Re: Request for extension of Final Delivery Date
Lucero Apartments (f/k/a Oak Creek Village) Austin, Texas
Fannie Mae Forward Commitment No.: 874426
PNC Loan No: 310401235

Re: Revised Report for Enclosure Assessment of the Oak Creek Village Apartments
WJE No. 2016.3106.1

Figure 1. Revised control joint layout per BCS, with construction alterations on Wilson St. marked up by WJE.

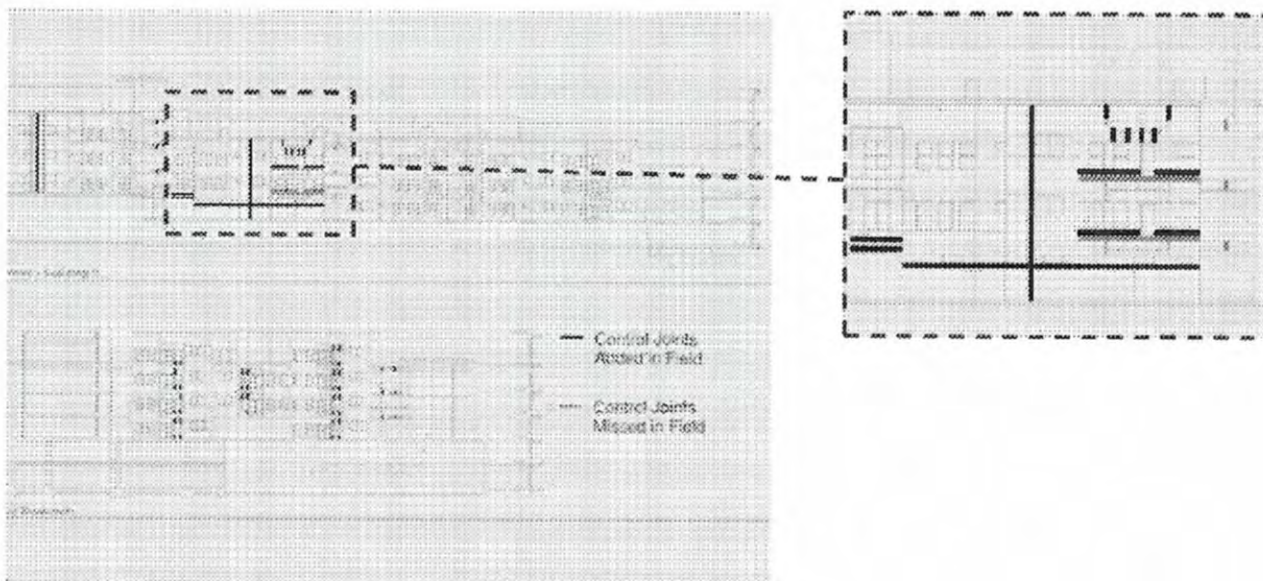
Although WJE, along with the initial design for control joint layout and Keller's suggestion, proposes that control joints be installed at the floor lines, the revised control joint layout produced does appear to generally comply with ASTM C1063 requirements. While the vast majority of control joints installed appear to be located in compliance with the intent of the revised control joint layout, WJE observed that a limited number of control joints were not located as depicted on the revised control joint layout, with several added but some eliminated or relocated (reference Figure 1).

Figure 2. Diagram submitted by Weis for VE proposal to replace EIFS system with Parex stucco system.

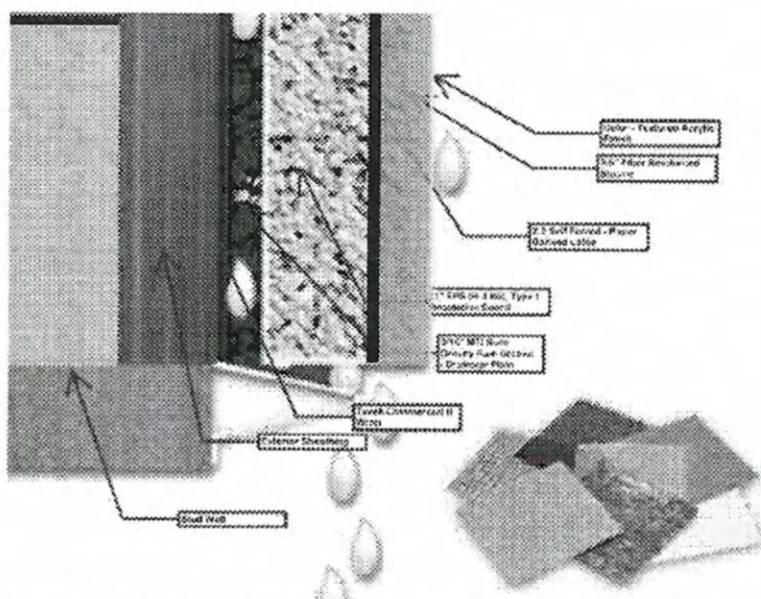
From a diagram issued via email by Weis (Figure 2) proposing a value engineering (VE) change from EIFS to stucco, we can see that the drainage of the wall system was to be provided at base terminations by a gap between the weep screed, located inboard of the drainage mat, and the metal casing bead terminating the EPS and stucco assembly.

In Weis's letter, they state that the weep screeds were installed per the relevant ICC ESR-2564; however, per Figure 2 in that document, the foundation weep screed is shown receiving the stucco, with no additional metal casing bead installed.

Figure 4. Cracking at balcony on Building D despite adjacency to control joint.

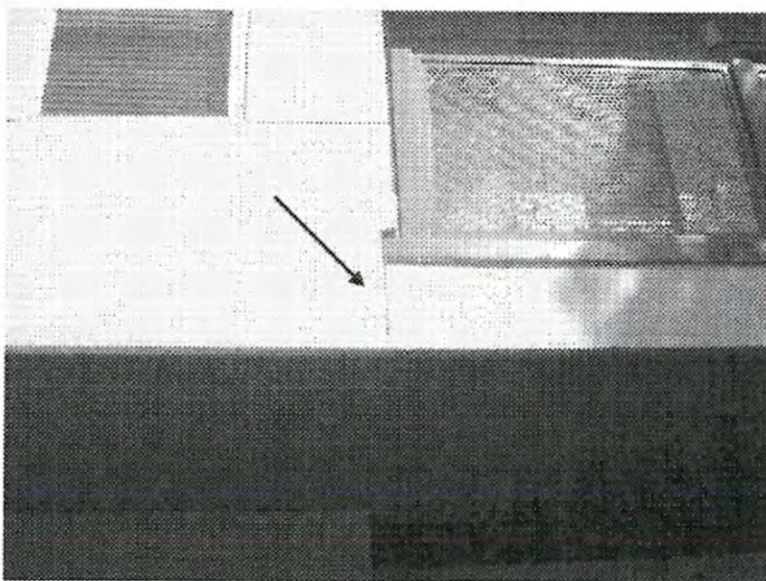
- Control joints not provided at floor lines and associated cracks in these locations (Figure 4 and Figure 5).
- Weep screeds not provided at base terminations of stucco at window and door heads (Figure 6 and Figure 7).
- Secondary trim installed at base terminations of stucco over foundation screeds (Figure 8).
- Casing bead flange at base of wall not embedded in stucco (Figure 9).
- No metal window sill framing to cover top of stucco assembly and separation between stucco and window frame at sills (Figure 10 and Figure 11).
- Perceptible texture variations at apparent stucco repairs (Figure 12 through Figure 17).
- Deflection joints at tops of columns stopped shy of reglet termination accessory (Figure 18). Cracking of the stucco was noted along these columns.

We noted a handful of cracks stemming from the bottom corners of both inset and protruding balconies. Although there are vertical control joints at the inset balcony corners, the function of the joints may have been compromised by Keller extending the lath through the joints, as stated in their submittal amendment and counter to the requirements of ASTM C1063, or fastening both sides of the joints. At the protruding balconies, the revised control joint layout did call for horizontal control joints at the top of the balcony; however, these control joints were instead installed at the bottom of the windows above.

We anticipate some increase in these types of crack over time with additional thermal cycling and building movement. These cracks can allow a larger volume of water than intended to enter through the cladding system, challenging weather barrier vulnerabilities. To mitigate future cracking of this type at locations where the control joints are missing or deficient, stucco could be removed to the nearest adjacent panels in these locations to allow for proper installation of control joints with cut lath per ASTM C1063. Alternatively, cracks could be sealed as part of ongoing maintenance.

Figure 7. Lack of weep screed at balcony door head, as well as apparent damage to head flashing.

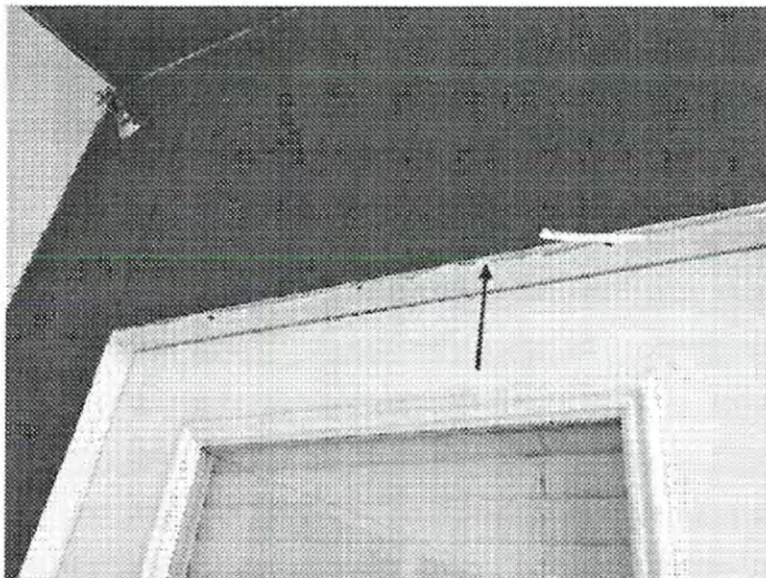
As for weeping the system above the window and door heads, we observed minimal cracks and separations at the heads of windows and doors, and with the head flashing observed as well as the gap between the head flashing and the stucco casing bead above, the wall appears capable of draining at the head locations.

Figure 10. Lack of sill flashing or window framing covering top of stucco assembly.

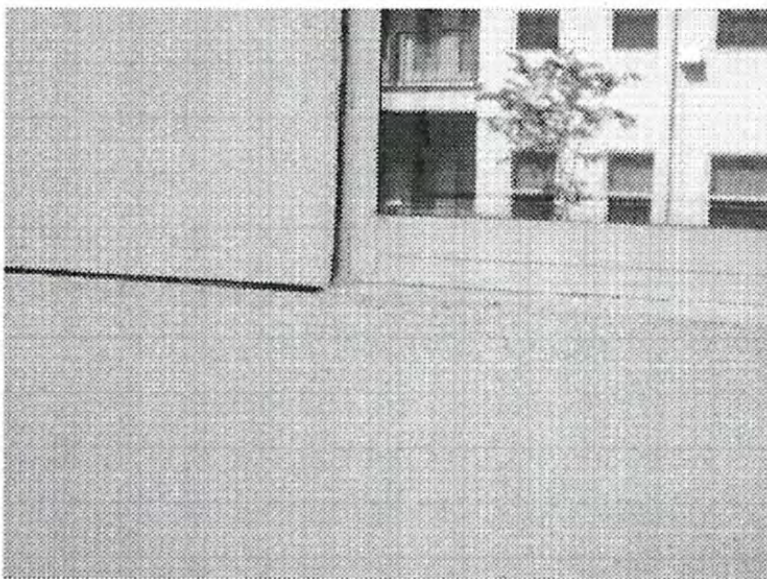
We observed the stucco system returning at an angle to meet the bottom of the windows, and we observed some cracking along the joint between the stucco and window system. As no sealant joint exists to accommodate differential movement of the window frames and stucco system, we would expect additional separation along this joint to develop over time. This separation can allow water to enter behind the cladding system. Although flashings and weather barriers are provided behind stucco, these are intended to manage incidental water only, and measures should be taken to seal openings and gaps that could allow larger volumes of water to penetrate the stucco. Blistering of coatings, efflorescence, lath corrosion, and leakage can all result from excessive water penetration behind stucco. We recommend that stucco below window frames be routed to provide a minimum 3/8-inch joint opening, and that a sealant joint be installed between the stucco and window frame, intersecting existing sealant joints at the jambs.

Figure 18. Crack visible at column adjacent to breezeway where deflection control joint has been filled with stucco.

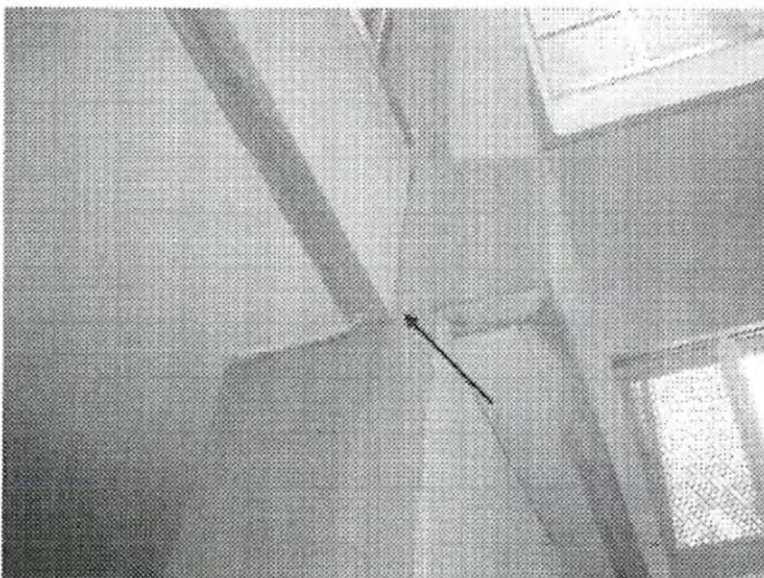
At the columns supporting the breezeways, we observed that the reveal providing for deflection at the top of the column stopped shy of the reglet, making the stucco continuous across the joint at those locations. We also observed corresponding cracking in these locations. Typically, stucco accessories would be provided in these and similar joints to accommodate differential movement of substrates and inhibit cracking between stucco panels.

Continued cracking can be expected at the interface of columns with the breezeways where the stucco is continuous, without a corner bead or other means of separation between stucco panels. To provide separation and accommodate movement, stucco can be cut out to allow for installation of corner casing beads separated by sealant and backer rod. Alternatively, stucco can be routed out along these vertical joints for installation of sealant and backer rod.

Figure 27. Cracking on all sides for much of height of column at Building C.

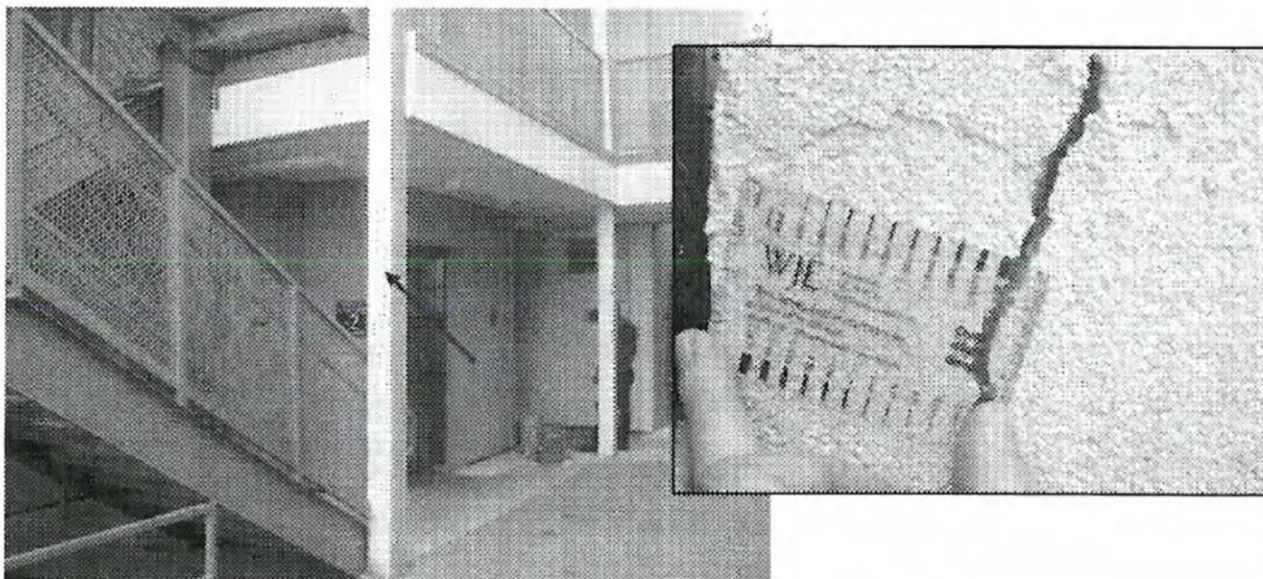
A purportedly wood column between Buildings C and D exhibited cracking almost its full height. WJE recommends complete removal of the stucco, installation of membrane flashing over the extents of the wood, and covering the column with formed sheet metal panels or similar to match the surrounding stair. We do not recommend reinstalling stucco in this location, given the geometry of the column and potential for future cracking with moisture content-related volume changes in the wood.

Figure 31. Lack of weather barrier tie-in at sheathing above mailboxes at Building C.

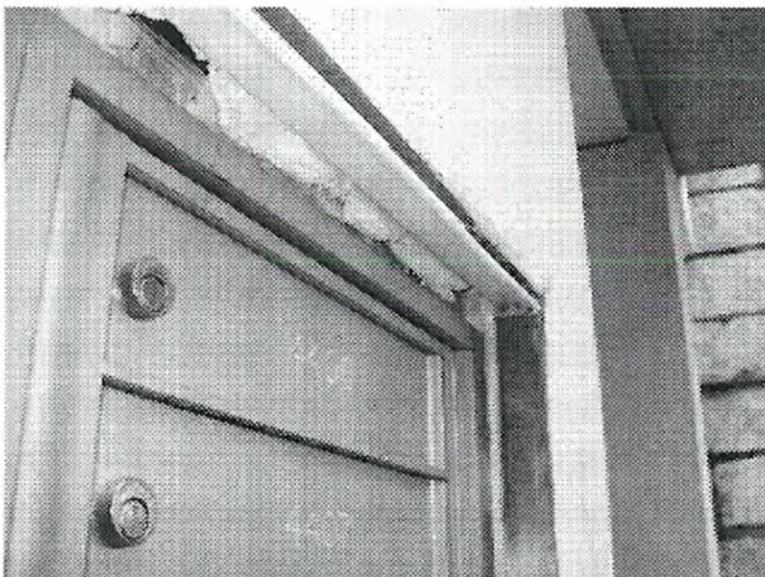
Some locations revealed a lack of weather barrier tie-in or edge termination between the stucco and interfacing system. These locations included the mailboxes at Building C, as well as two low roof-to-stucco

interfaces at Building A. At the mailboxes, both the stucco and mailboxes should be removed to allow for installation of membrane flashing into the perimeter of the rough opening to ensure continuity of the air and moisture barrier system. **Sheet metal closures may be required at the perimeter of the stucco opening around the mailboxes.**

Figure 33. Fire hose spigot penetration not sealed at face of stucco on Building A.

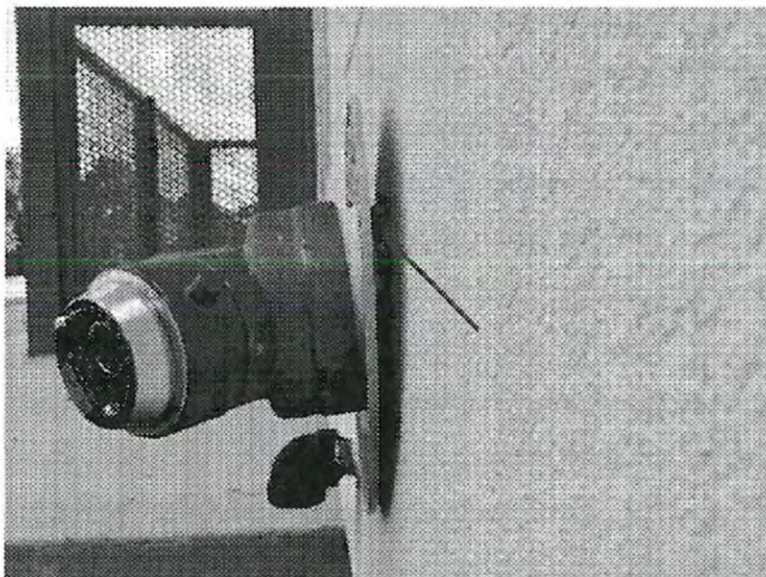
We also observed a number of penetrations through the stucco that did not appear to be sealed and one location where the sealant had separated. In locations of apparent lack of continuity between the weather barrier and adjacent opening or roof system, water can leak into the building interior, leading to damage of wall components and finish materials. At locations of unsealed penetrations, it was unclear if the penetration was added subsequent to installation of the stucco; penetrations added after stucco installation may not be adequately integrated into the weather barrier system, **which can also lead to water infiltration. We recommend adding sealant to the untreated penetrations and repairing any separated sealant.**

Figure 34. Mechanical damage to stucco on Building A.

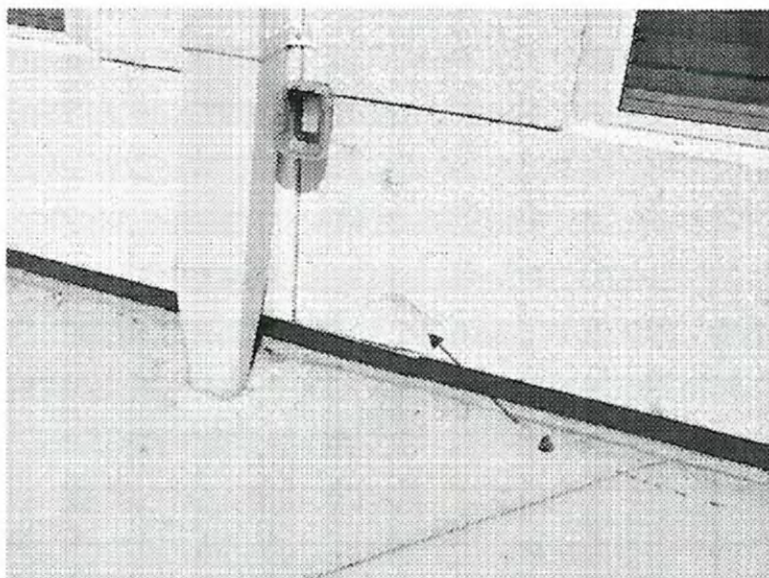
In a limited number of locations, we observed mechanical damage to the stucco. These areas should be repaired and recoated.

Figure 39. Relocated downspout reveals lack of coating and abandoned fastener penetrations in stucco.

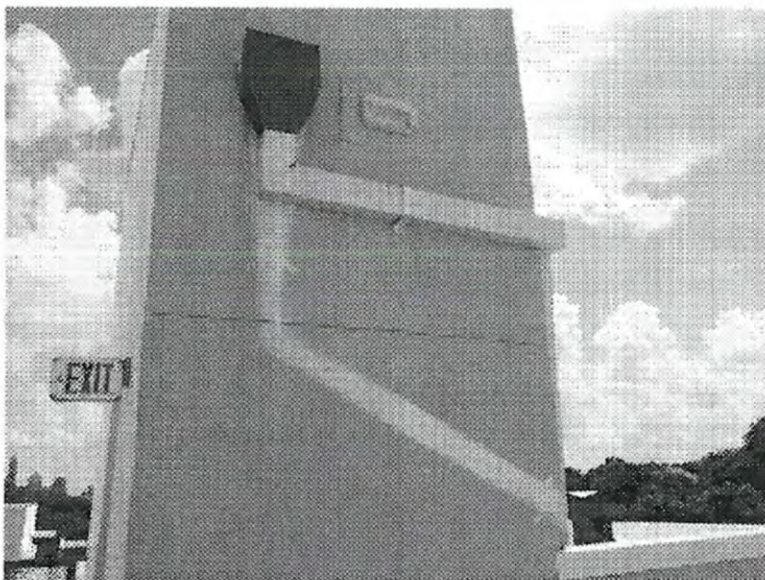
Where one downspout was relocated at the base of Building A, the stucco surface was not coated, and abandoned fastener penetrations were present. The penetrations should be repaired, and the stucco and utilities should be painted to match adjacent panel colors.

Figure 45. Crack between Buildings A and B at west elevation; note lack of building expansion joint in this location.

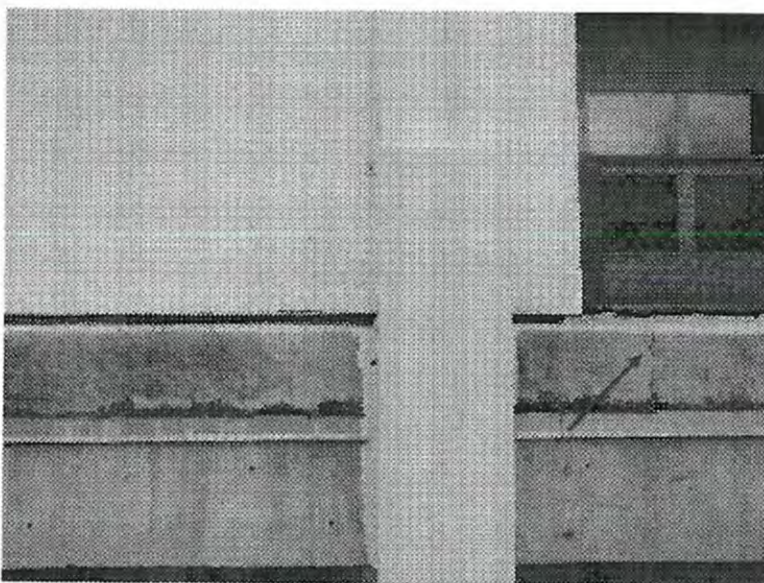
Despite the indications on the architectural and structural drawings, we did not observe any expansion joints in the as-constructed conditions between buildings or within cladding materials. We did observe an increase in the frequency of separations at the soffit panel joints near breezeway connections between buildings. The differential movement of separate buildings may explain distress at soffit panels as well as the stucco at nearby column heads, promoting separation.

Currently, evidence of differential movement between buildings was observed at the podium concrete, in cracks at the stucco, and at separations of soffit panel joints near the adjoining breezeways; however, continued damage may occur over time if this condition is not addressed. We recommend providing the expansion joints in the exterior finishes at locations indicated in the construction drawings as well as an additional set between the two segments of Building C.

Figure 46. Efflorescence visible with active wetting at split-slab condition of podium.

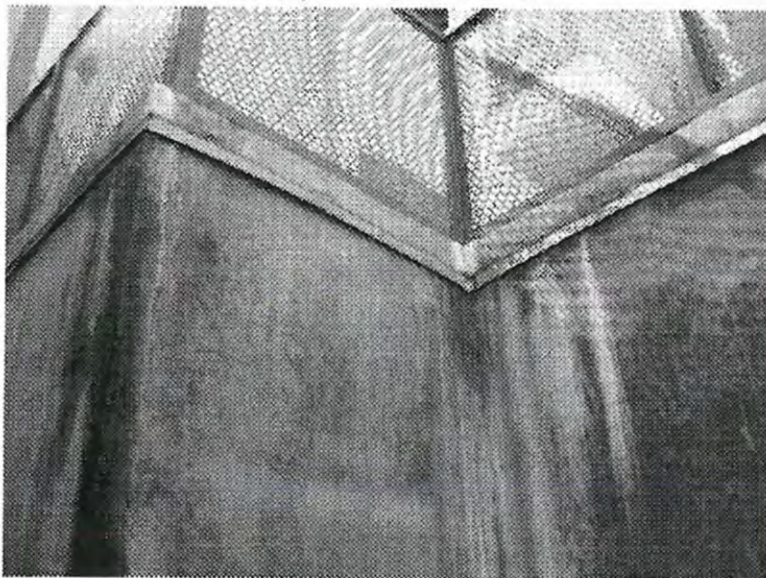
We observed a significant amount of efflorescence stemming from the split-slab waterproofing system at the podium, along with some staining from the railing above. This efflorescence appears to be a result of water migrating through the finished surface over the podium, where it contacts the waterproofing surface and drains to the exterior, between the structural and topping slabs. This is primarily an aesthetic concern. Efflorescence can be cleaned from the surface of concrete masonry cleaning solutions but will reappear with additional water migration. It may lessen gradually over time as the amount of water-soluble mineral salts within the concrete is reduced. The corrosion from the railing above, however, can lead to premature failure of the systems, and, indeed, a spall appears to have formed at one corner of the concrete supporting the railing. Refer to the recommendation above regarding the railing. Concrete spalls can be removed and patched.

Figure 48. Spray foam used to seal conduit hoods on roof.

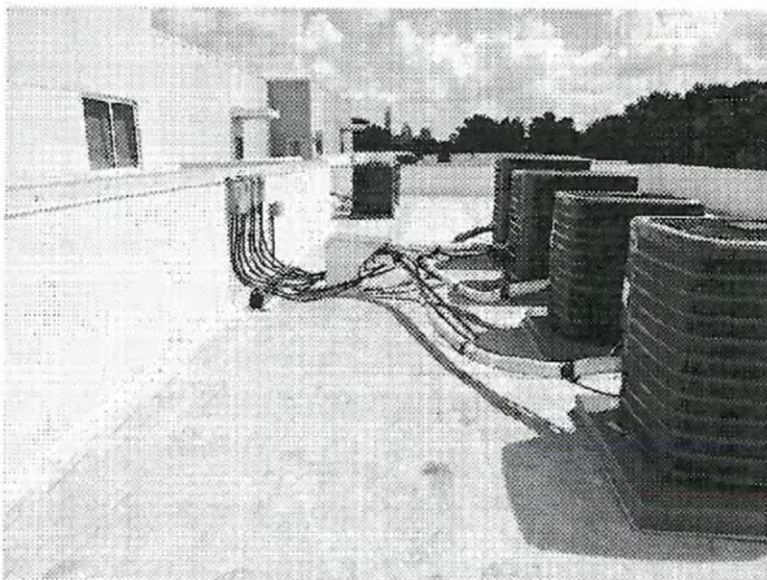
At the roof level, we observed several conduit hoods with spray polyurethane foam (SPF) used to provide an air seal around the conduit. Because SPF is not UV stable, it will deteriorate quickly, resulting in discontinuity in the air and moisture barrier. This could potentially lead to condensation or water infiltration to the building interior. We recommend cutting back the exposed SPF and covering the opening with a metal panel notched around the conduit and then sealed at the perimeter and conduit interfaces.

Figure 50. Large area of apparent ponding water on eastern portion of roof over Building C.

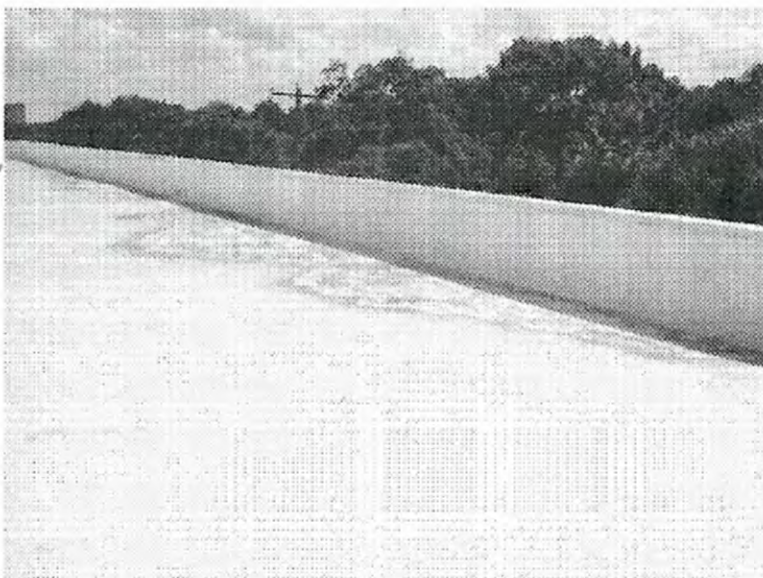
One sizeable area of ponding water on the roof was noted on the east side of Building C. We understand from Weis's response letter that the roofing manufacturer has provided a warranty. While many roofing warranties exclude ponding, this one does not. Therefore, even though the ponding can lead to premature deterioration of the roof membrane, we expect the warranty to cover this issue for the expected life of the roof system.
